Application No.	Applicant(s)		
	10/517,213	YAMANE, MITOKU		
Office Action Summary	Examiner	Art Unit		
	Quoc A. Tran	2176		
The MAILING DATE of this communication app Period for Reply	ears on the cover sheet with the c	orrespondence address		
A SHORTENED STATUTORY PERIOD FOR REPLY WHICHEVER IS LONGER, FROM THE MAILING DA - Extensions of time may be available under the provisions of 37 CFR 1.13 after SIX (6) MONTHS from the mailing date of this communication. - If NO period for reply is specified above, the maximum statutory period w - Failure to reply within the set or extended period for reply will, by statute, Any reply received by the Office later than three months after the mailing earned patent term adjustment. See 37 CFR 1.704(b).	ATE OF THIS COMMUNICATION 36(a). In no event, however, may a reply be time will apply and will expire SIX (6) MONTHS from cause the application to become ABANDONE	N. nely filed the mailing date of this communication. D (35 U.S.C. § 133).

DETAILED ACTION

This action is a **Final Office Action** in response to amendments/remarks filed 07/07/2008, which claimed priority of PCT/JP03/05469 04/28/2003 and JAPAN 2002-174185 dated *06/14/2002*. Claims 1-2,

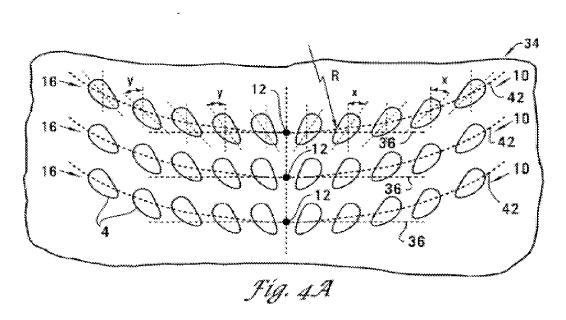
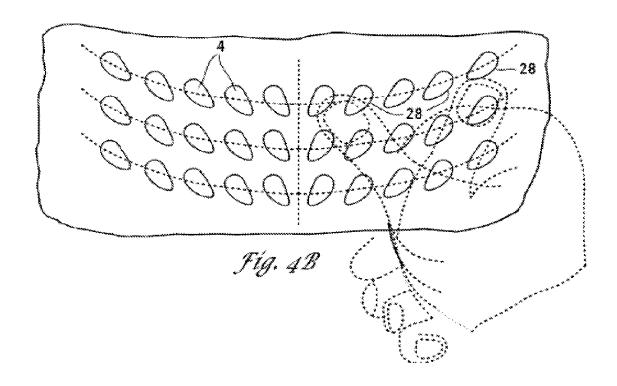
First input means having first character-input keys assigned to a matrix configuration wherein said first character-input keys have different vertical and horizontal widths; the longitudinal axes of said first character-input keys being tilted in a top view; said second characters-input keys being arranged in a region different from a region where said first character-input keys are arranged,

(See Fig. 2-5 and Para 17, 21 and → Kang discloses this limitation that is keyboards (i.e. the front view of the PDA item 24 in FIG. 5 includes the keyboard 34 in FIG. 4A. The PDA 24 includes a touch sensitive screen 44.) The keyboard 34 in FIG. 5 includes a number of other keys 48, which provided on other handheld electronic devices such as two-way pagers, cellular phones and the like; wherein keyboards 30-34 having different key layouts facilitate access of the keys 4 by sweeping actions of the thumbs. Each row 10, 16 of keys 4 is tilted above a horizontal line 36 through its origin 12 so that each key

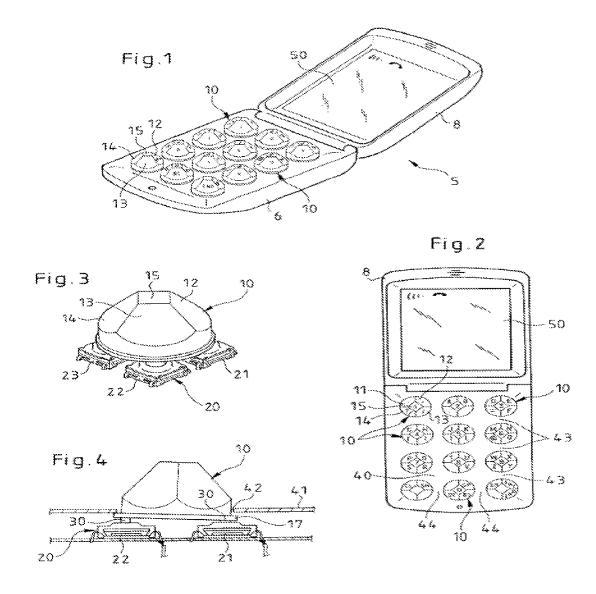
display means for displaying the characters input by said first input means and said second input means.

(See Fig. 5 and Para 18 and →Kang discloses this limitation that is keyboards of the front view of the PDA item 24 in FIG. 5 includes the keyboard 34 in FIG. 4A. The PDA 24 includes a touch sensitive screen 44. The keyboard 34 in FIG. 5 includes a number of other keys 48.)

FIG. 1b

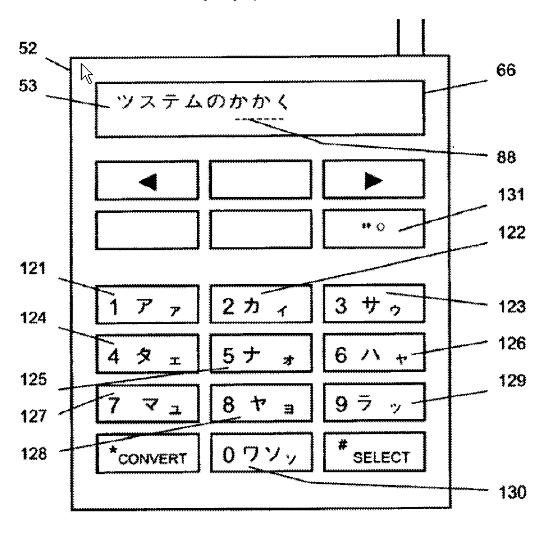
said characters assigned to each of said ends of said first character-input keys being phonetic letters; a second input means having second character-input keys provided for entering alphabets expressing Japanese vowels,

(See Fig. 1B and at Column 21 Lines 20-65→ Kushler discloses this limitation that is a handheld device includes a schematic view of a cellular telephone keypad, similar to FIG. 1b, wherein one or more of the data entry keys are associated with a plurality of

romaji characters (Latin letters used to phonetically spell the pronunciations of Japanese kana characters), and are labeled with each of the romaji characters associated with the key. An input sequence is generated each time an input is selected by user manipulation of the input device. The generated input sequence has a textual interpretation that is ambiguous due to the plurality of romaji characters associated with one or more of the data entry keys.)
